OhioEPA
State of Ohio Environmental Protection Agency
Northeast District Office

RE: LORAIN
BLACK-ROCKY RIVER WATERSHED
CITY OF OBERLIN
MUNICIPAL STORM WATER PROGRAM
AUDIT FINDINGS

Municipal Storm Water Program Evaluation

MS4 Maintenance Component Worksheet

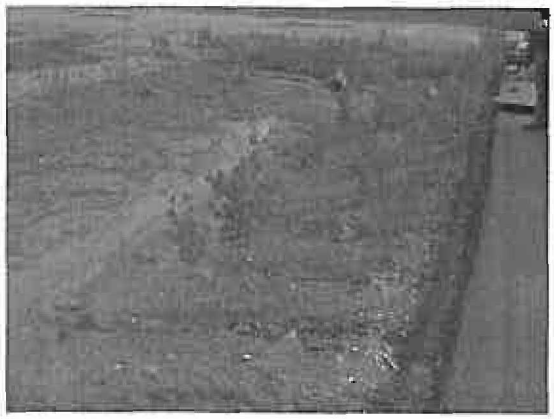
Fig 10 (LEFT): This bioretention cell has become overgrown with weeds and is not properly functioning. The cell needs to be replanted with the proper plants and maintained fittingly.

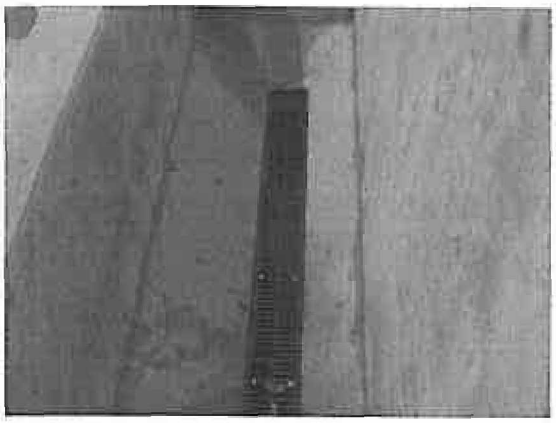
Fig 11 (LEFT)/ 12 (RIGHT): This swale preceding the detention basin needs to be stabilized. Sediment from the stockpile in figure 11 is draining right to the basin along with the rest of the runoff from the swale itself.

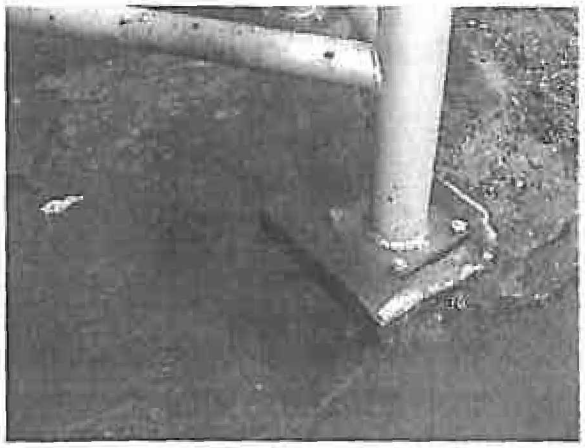
Fig 3 (LEFT): The oil vapor vent for engine #5 is showing major signs of leakage. Because the engine is no longer in use, it would be a good practice to abandon the vent and clean the surrounding area, avoiding runoff into the storm drains nearby. The system to capture vapors must be improved for vents from operating engines.
